**CITY OF SARATOGA SPRINGS
CITY COUNCIL MEETING**

Tuesday, January 19, 2016

Report Date:	Tuesday, January 12, 2016
Applicant:	Peter Staks
Owner:	Wardley Companies
Location:	2232 & 2246 S Talons Cove Drive
Major Street Access:	Redwood Road, and Fairway Boulevard
Parcel Number(s) & Size:	59:001:0069, ~4.84 acres
Parcel Zoning:	RC
Adjacent Zoning:	R-3, R-10, R-3PUD
Current Use of Parcel:	Undeveloped
Adjacent Uses:	Low and Medium Residential, golf course, and golf course clubhouse
Previous Meetings:	Staff review of Concept Plan (May 29, 2015) Planning Commission Hearing (November 12, 2015, continued) Planning Commission Meeting (December 10, 2015)
Previous Approvals:	None
Type of Action:	Administrative
Land Use Authority:	City Council
Future Routing:	None
Author:	Kara Knighton, Planner I

Author: Jeremy D. Lapin, City Engineer
Subject: The Fairways Office Park (Talons Cove)
Date: January 19, 2016
Type of Item: Site Plan Approval

ARCHITECTURAL SITE PLAN

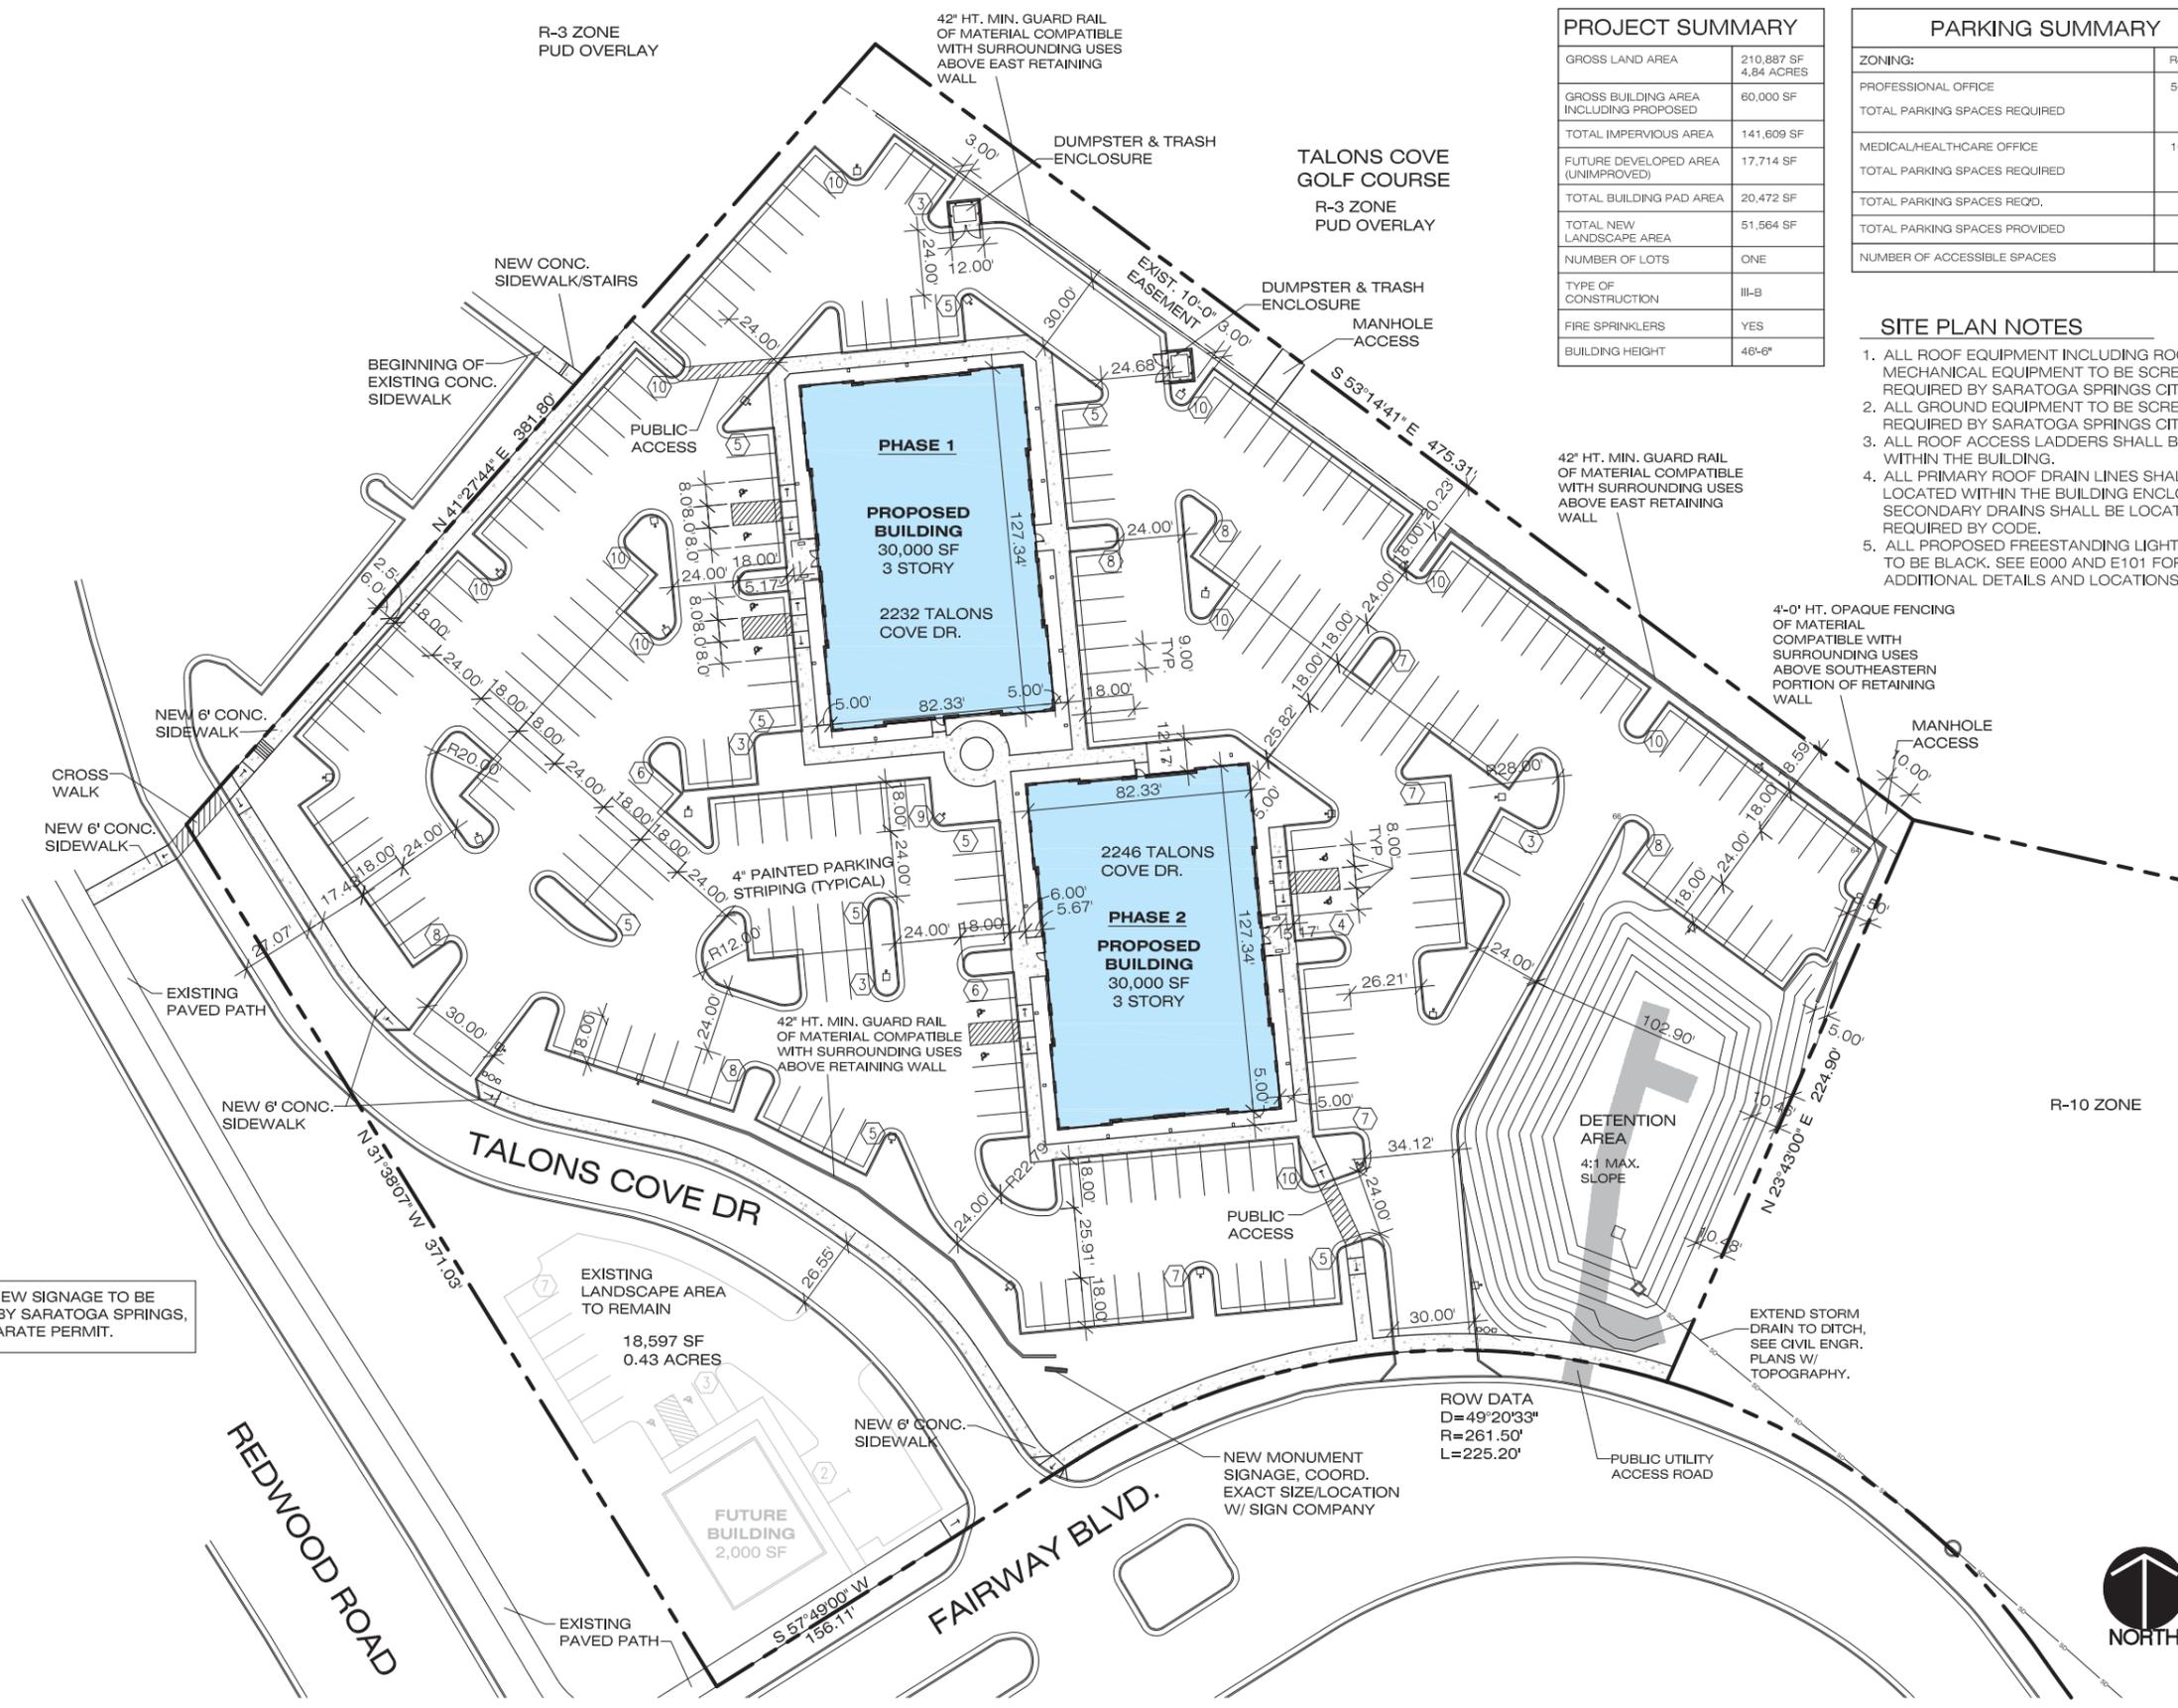
- 19.04, Land Use Zones: **Complies**
 - Setbacks: **Complies.** "In addition to the specific setback requirements noted above, no building shall be closer than five feet from any private road, driveway, or parking space." There is 5'2" from the entrance posts to the parking lot as shown in detail 1A on sheet SD.3.

- 30' rear setback required when adjacent to a Residential zone. The rear setback is approximately 120'.
 - “In addition to the specific setback requirements noted above, no building shall be closer than five feet from any private road, driveway, or parking space.”
Complies. The covered building entrance posts have been moved back so that there is 5'2" between the posts and the parking space. See detail 1A on SD.3.

- All freestanding light fixtures shall be black. **Complies.** SD.1 item 5 under Site Plan Notes calls out that all proposed freestanding light fixtures shall be black. The lighting plan E000 and E101 need to be updated to match the Site Plan.

LANDSCAPE PLAN

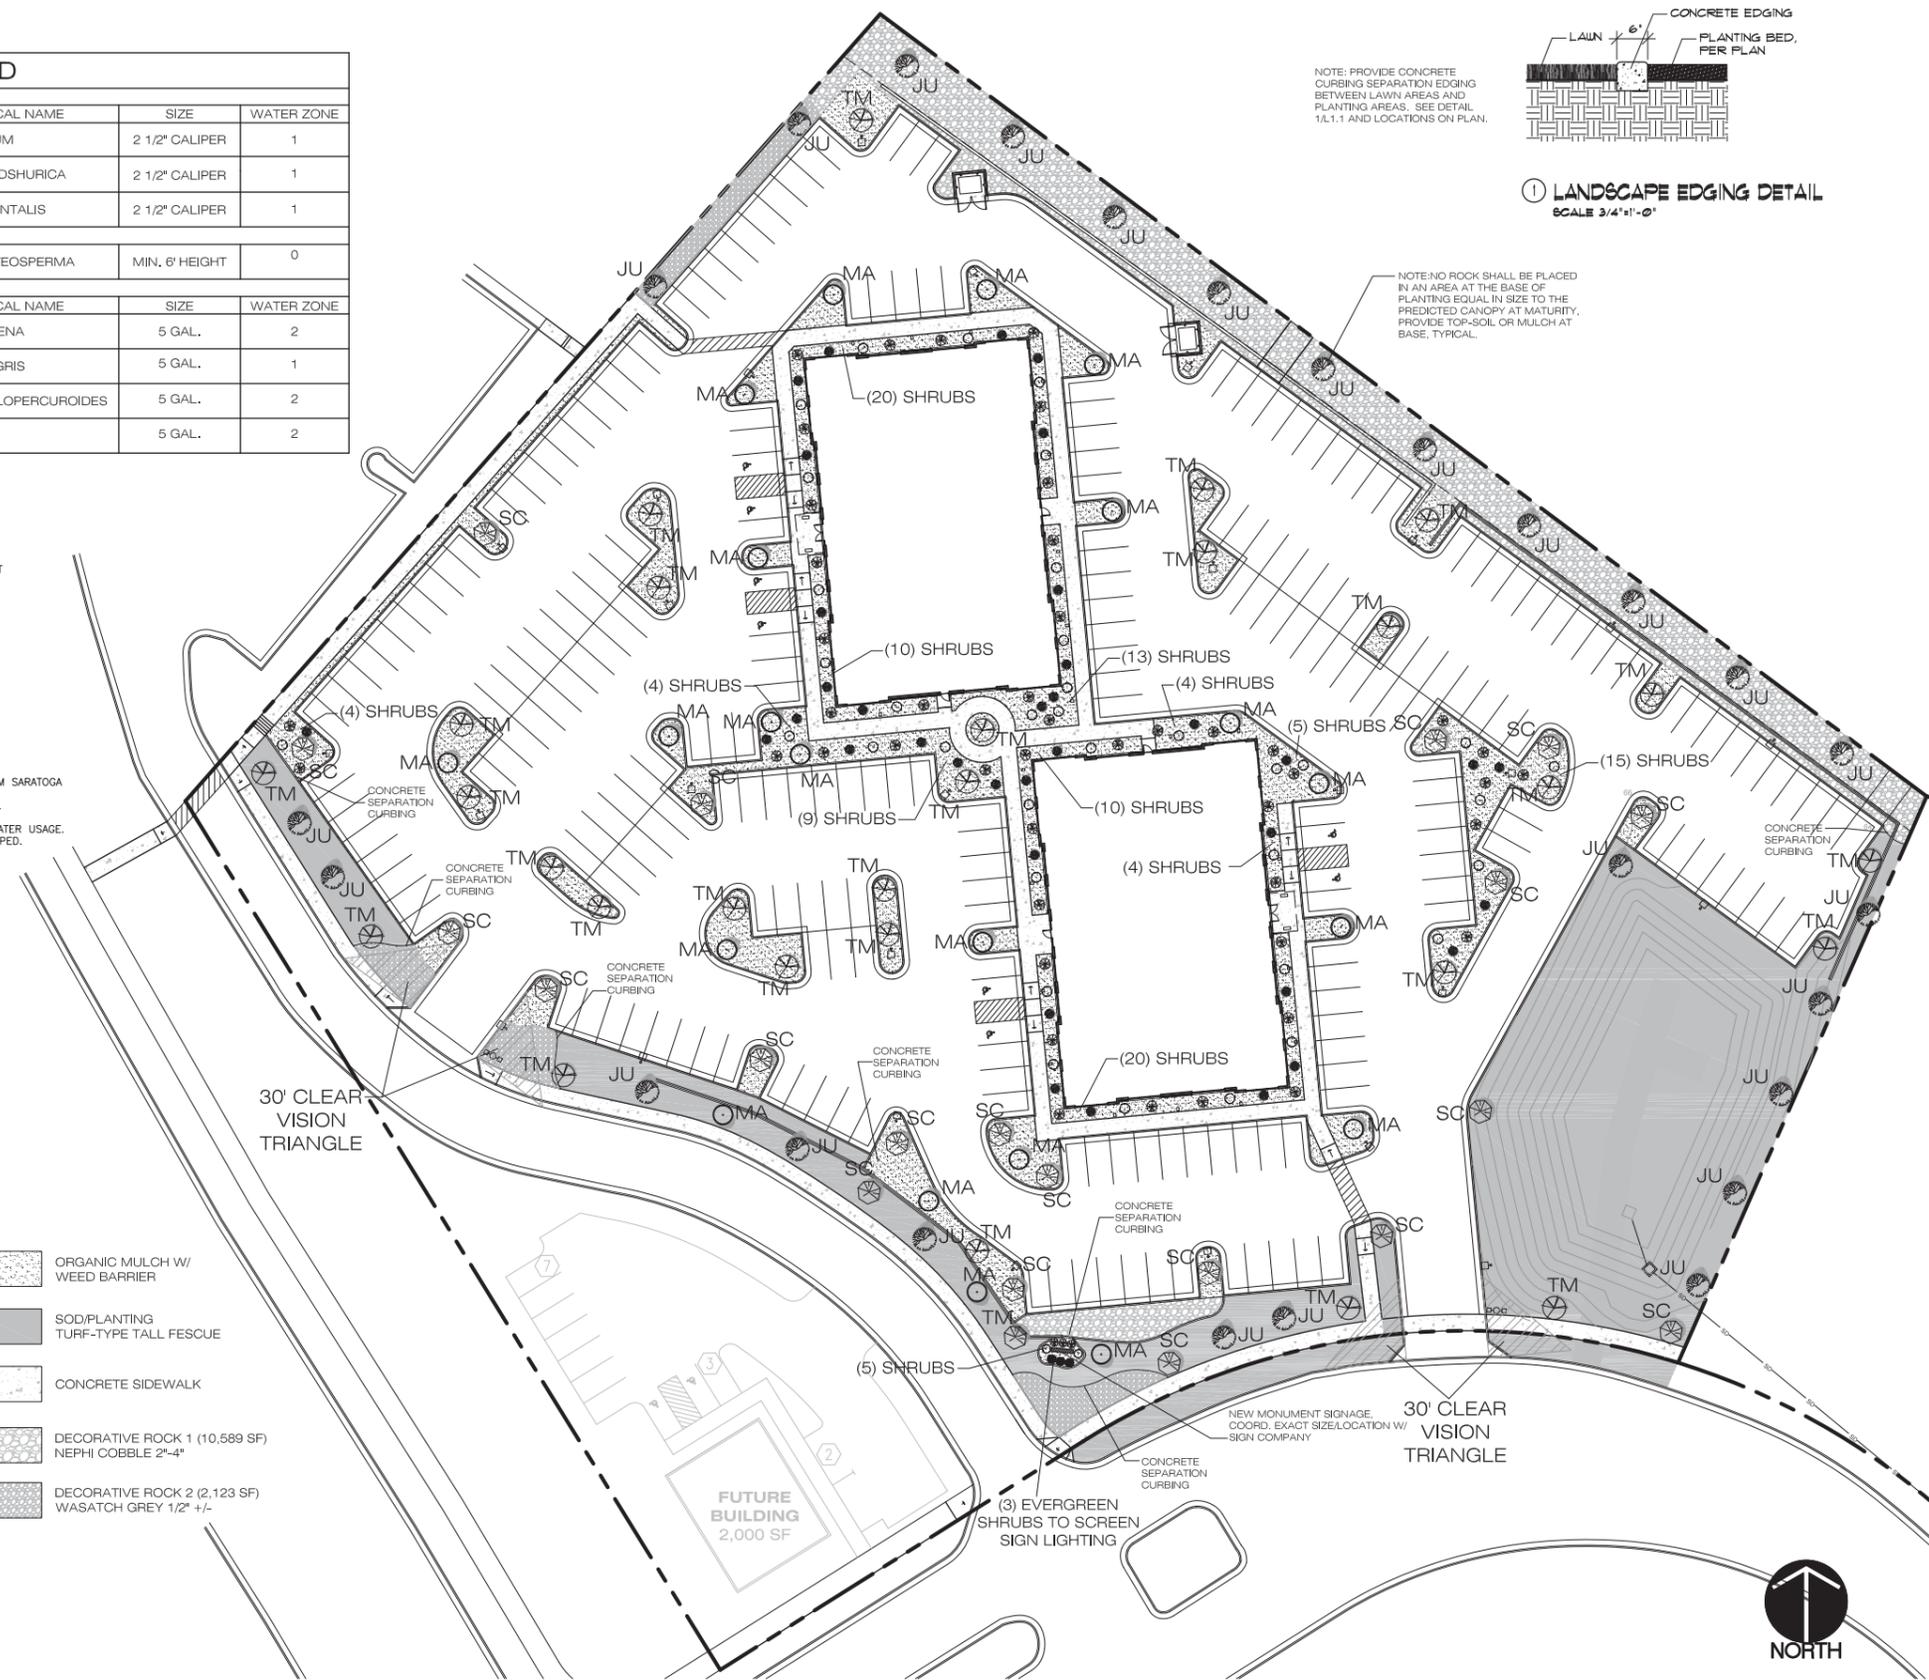
- 19.06, Landscaping and Fencing: **Complies.**
 - Planting and Shrub beds: **Complies.** Concrete edging is proposed to separate lawn and the planting and shrub beds.

- Rock: Complies. Rock mulch is proposed in two different colors (Nephi Cobble and Wasatch Grey) and sizes that range from ½” to 4”.
 - Planting and Shrub beds: Complies. Concrete edging is identified to separate lawn and shrub beds. Organic mulch is proposed in the shrub beds.
